Addendum #1

Public Works Trench Drain Replacement

Addendum #1 consists of the following Questions and Answers which clarify and provide supplemental information for the above captioned Bid. In addition, we have provided the Manufacturer Specification sheet for additional install information.

12 [305] WIDE REVEAL TRENCH DRAIN SYSTEM WITH STEEL FRAME

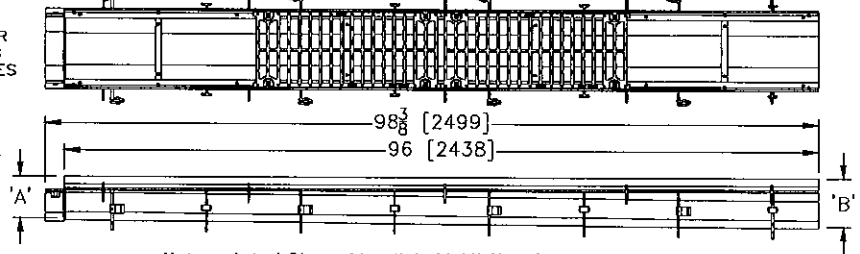
Answer: Install trench drain per manufactures recommendations, match existing concrete floor thickness.
10. Question: Please provide dimension length of trench drain using scale shown on plans. May be different from the actual length

Answer: See attached Manufacturer Specification Sheet.
11. Question: Show dimension, width and length of concrete to be removed & replaced.
Answer: See attached Manufacturer Specification Sheet.
